ADMINISTRATIVE AMENDMENT
 File # C24A-C083 Project # 1002149
 To allow a shift of 3 feet to the west of the additional 26 ft to Bldg. 6
 Approved by: [Signature] DATE: 6-15-04

ENGINEER'S SEAL: [Signature]
 DRAWN BY: BGC
 DATE: 04/20/04
 PROJECT: ADMINISTRATIVE AMENDMENT SITE PLAN FOR SUBDIVISION
 SHEET # 2
 TITRA WEST LLC
 8500 JEFFERSON NE
 ALBUQUERQUE, NEW MEXICO 87113
 (505)858-3100
 FORWALD B. BOHANNAN
 P.E. #7468

QUAL RIDGE SHOPPING CENTER ADMINISTRATIVE ADJUMENT SITE PLAN FOR BUILDING PERMIT

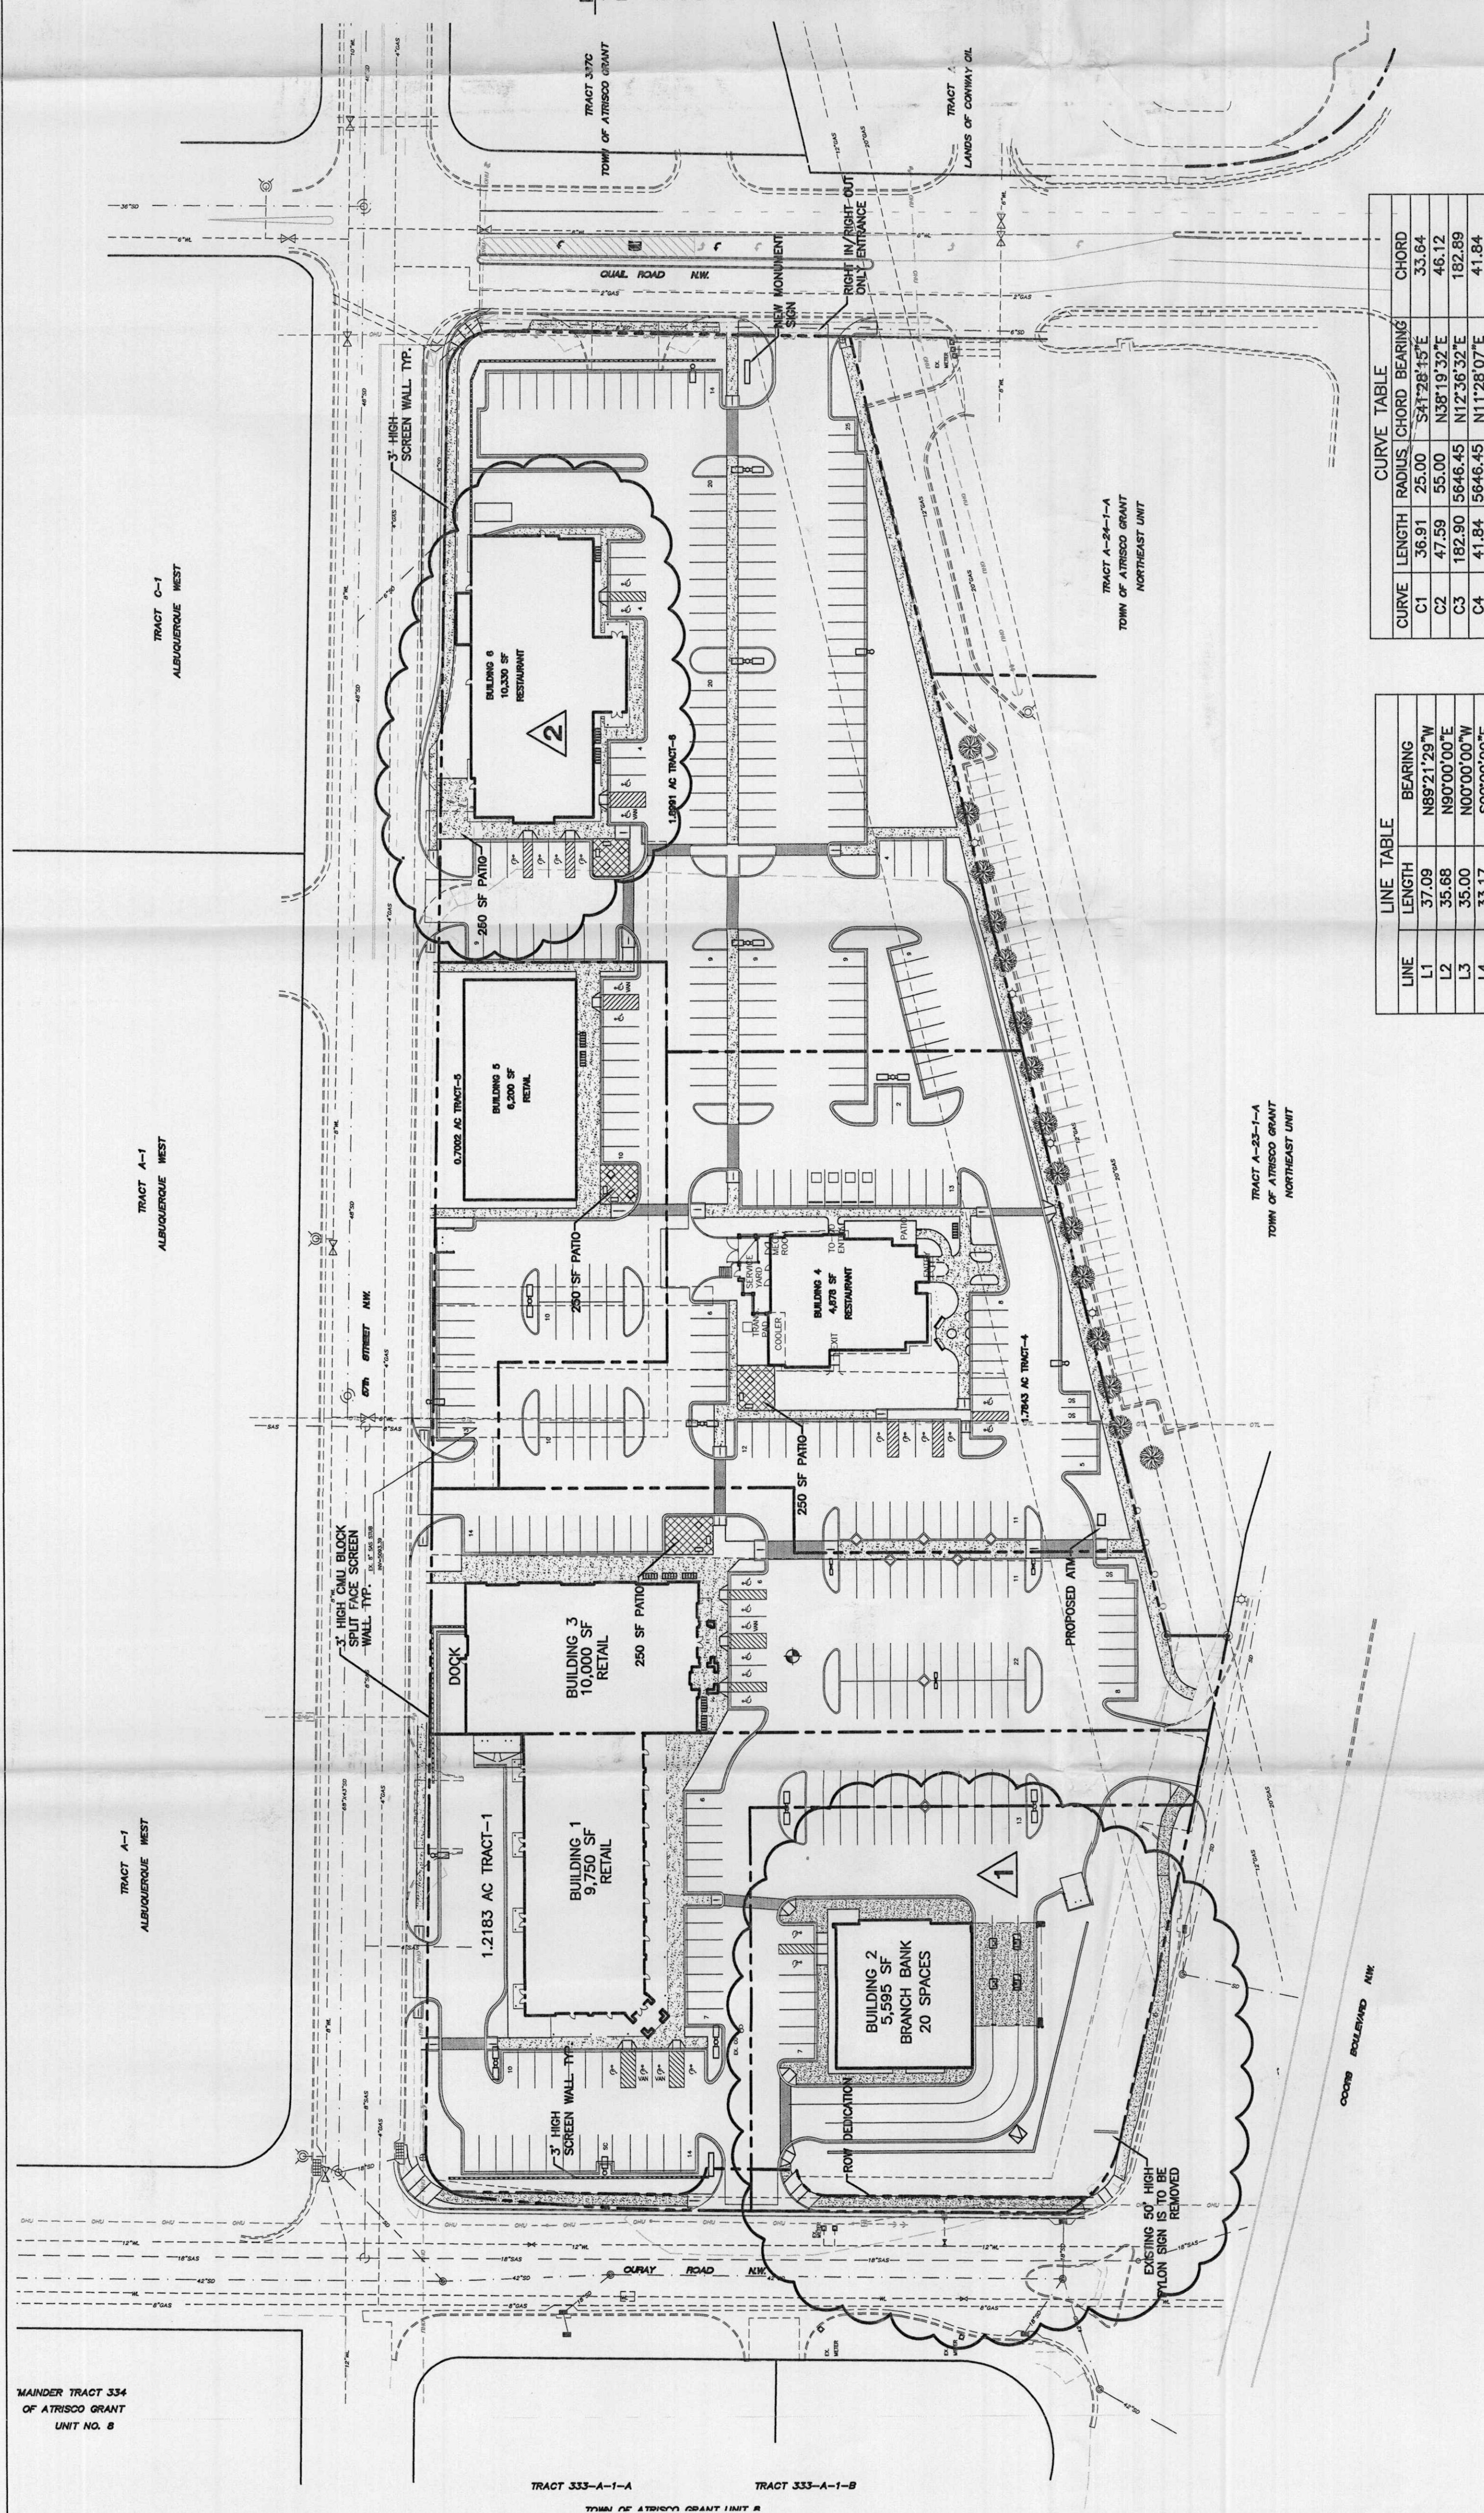
NO.	DATE	REVISIONS
2	05/20/04	MOVED BUILDING EAST
1	12/24/03	CHANGED BUILDING 2 LAYOUT

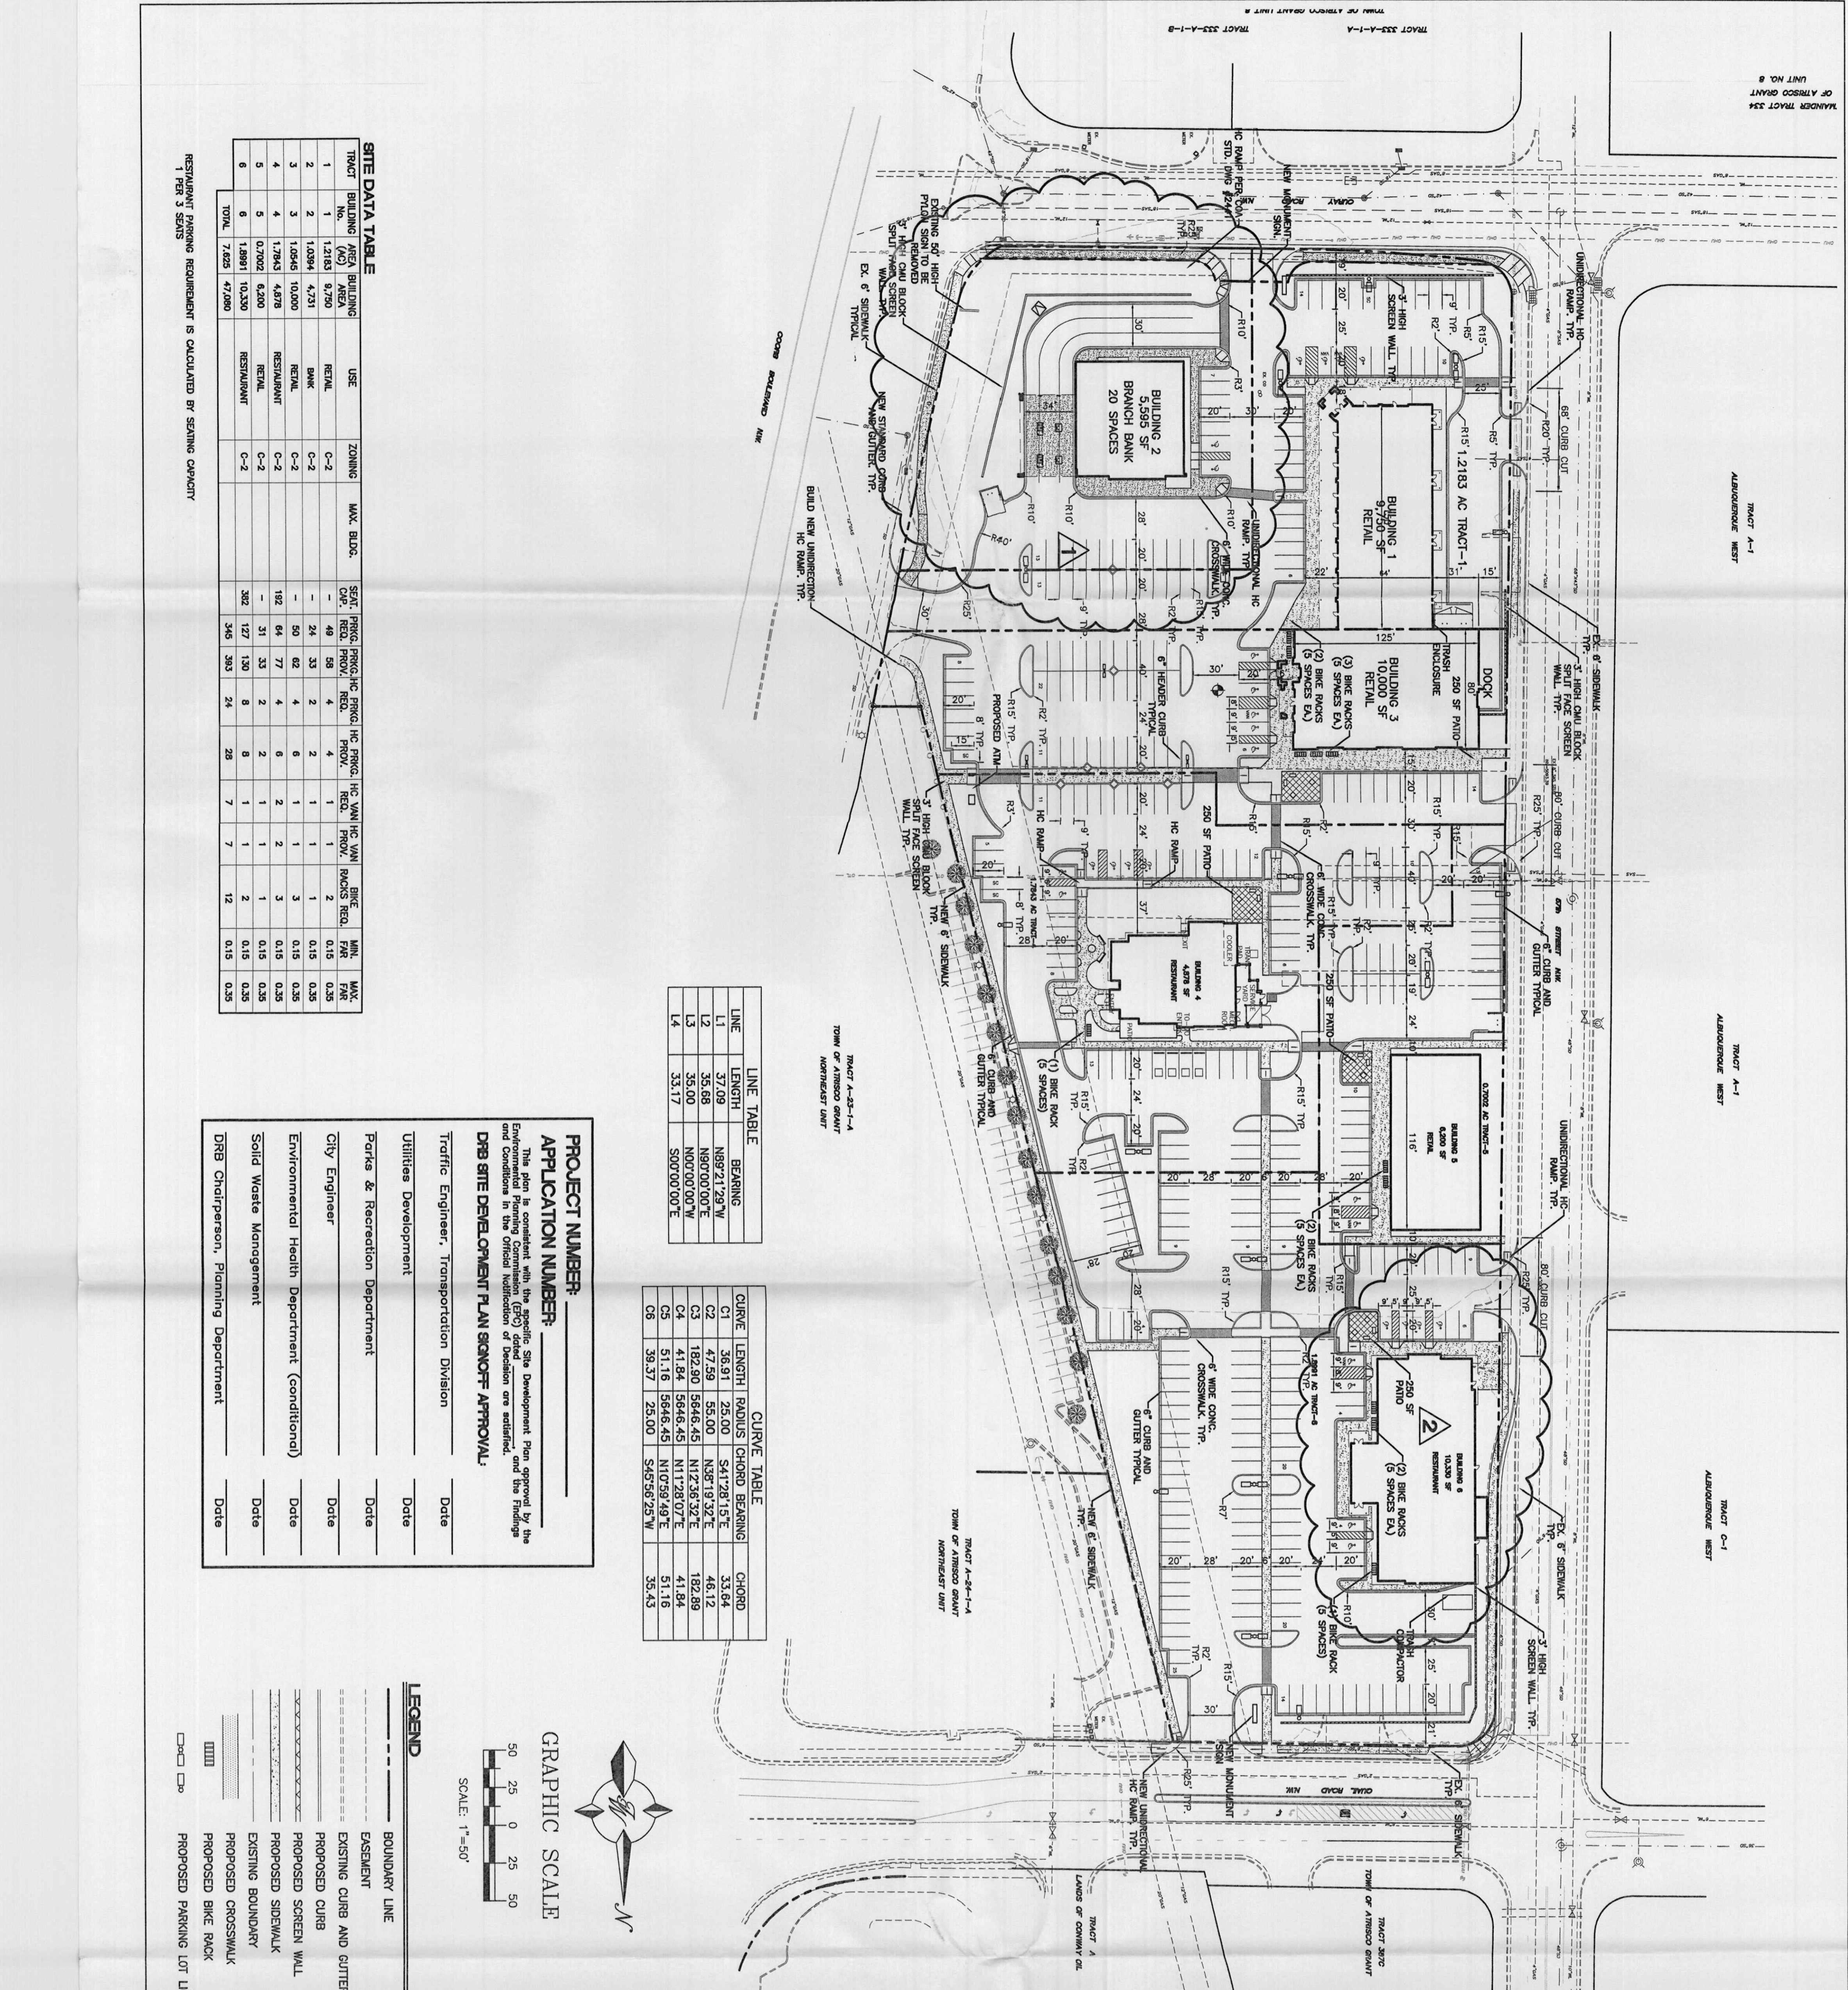
NO.	DATE	REVISIONS
1	12/29/03	CHANGED BUILDING 2 LAYOUT
2	03/20/04	MOVED BUILDING EAST
